Agenda Request: Consideration of Final Report, Evaluation of the Treatment Performance for Thomasville Road Stormwater Management Facility No.4 and recommendations included therein.

2. Dr. Harper's Peer Review of the County's Analysis of the Stormwater Management Facility No.4's Performance at Build-Out

# SWMF Number 4 Basin General Location Map

Figure 2-2. Relationships Between Pond Water Elevation and Infiltration Rates.

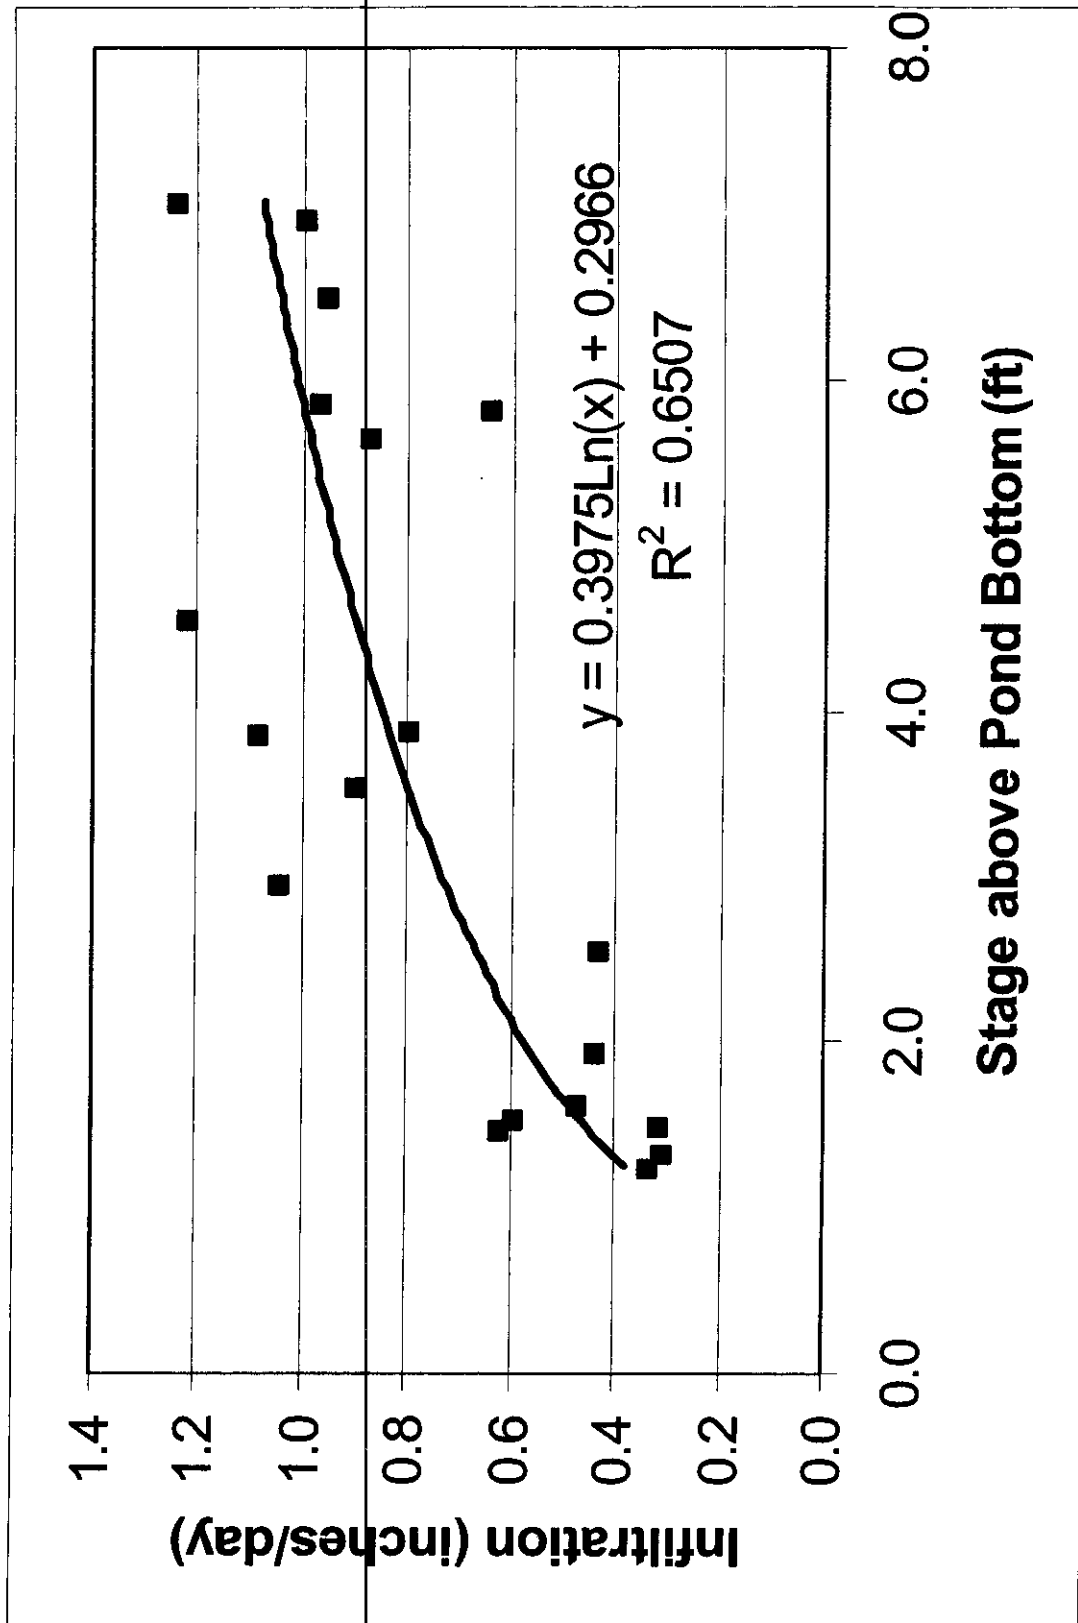
The relationship between pond water elevation and calculated infiltration rates is indicated on Figure 2-2. The data suggest a curvilinear relationship which provides a best fit to a logarithmic function. The R-square value for this relationship is 0.65, indicating that the relationship between water depth and infiltration explains 65% of the variability in the measured data. The relationship presented in Figure 2-2 is used by ERD in the modified model to calculate pond infiltration as a function of elevation above the pond bottom.

The Leon County model was modified by ERD to include separate estimates of infiltration and evaporation. Evaporation is assumed to vary on a monthly basis, based upon the values summarized in Table 2-5. Infiltration losses are calculated based upon water depth within the pond using the relationship summarized in Figure 2-2.
